DATE: 8-11-17

APPLIES TO: This service bulletin applies to 2008 – 2017 model year Furion, Gladiator, and Metro Star model chassis cabs built between August 27, 2007 and April 27, 2017.

CONDITION: Fasteners securing rear cab lockdown bracket to frame failing.

CORRECTION: Replace fasteners and install at higher torque. Install rear cab support bumper.

FIG. 3-1

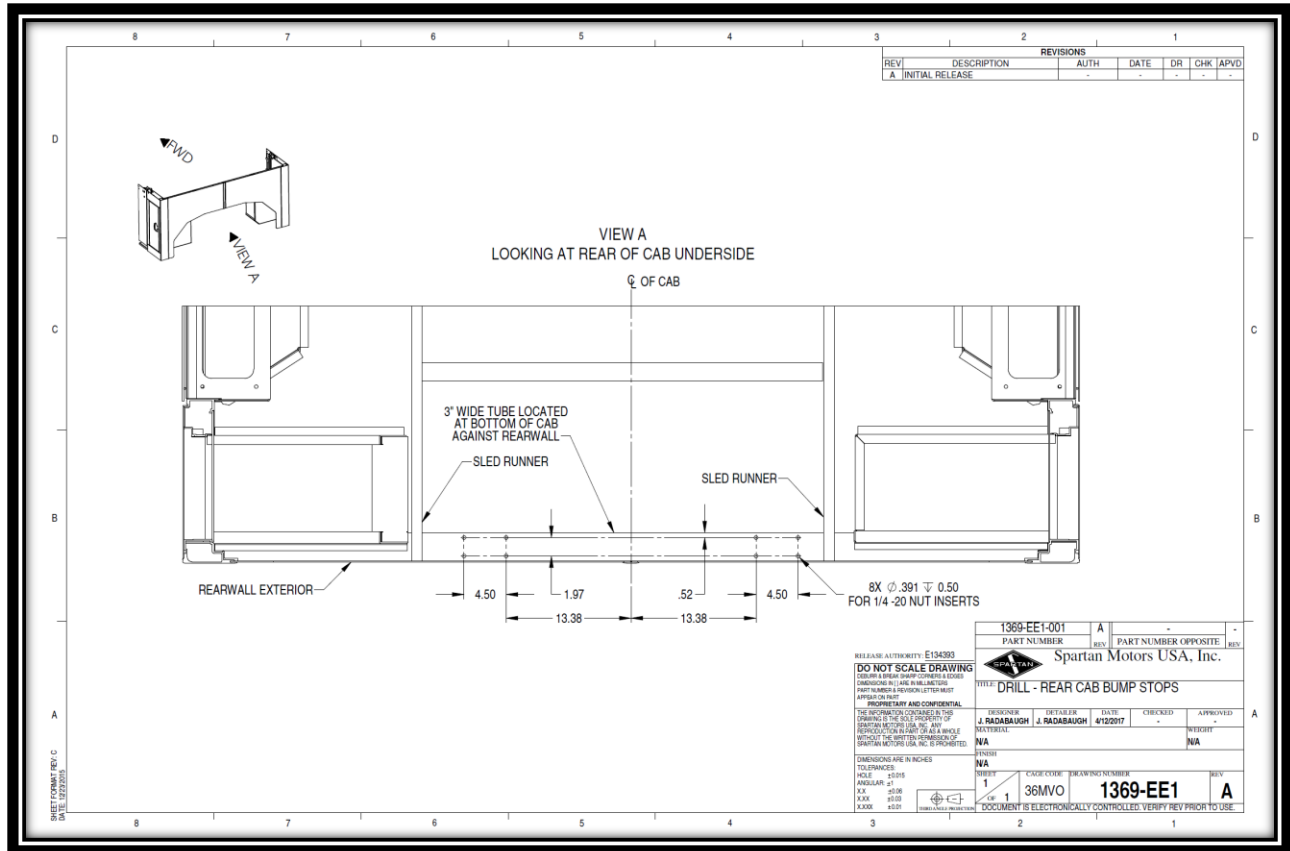
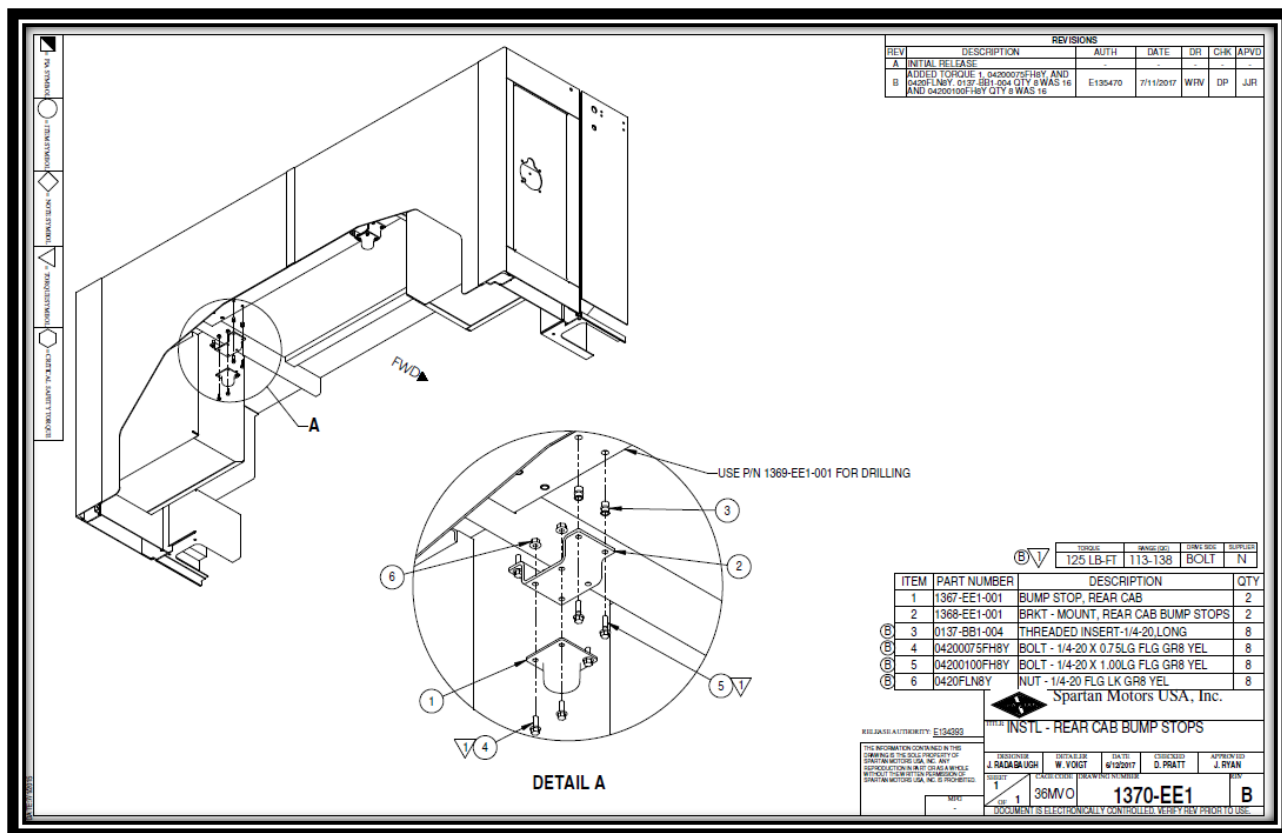
1. Tilt cab to gain access to bottom side of cab.
2. Using drilling 1369-EE1-001 center punch all 8 hole locations in rear most cross brace. Refer to FIG. 3-1.

3. Pre drill each hole using a 1/8" drill bit. Once all holes have been pre drilled, use a 25"/64" drill bit for finishing.
4. Use installation 1370-EE1 To complete steps 5 through 8. Refer to Fig 4-1.
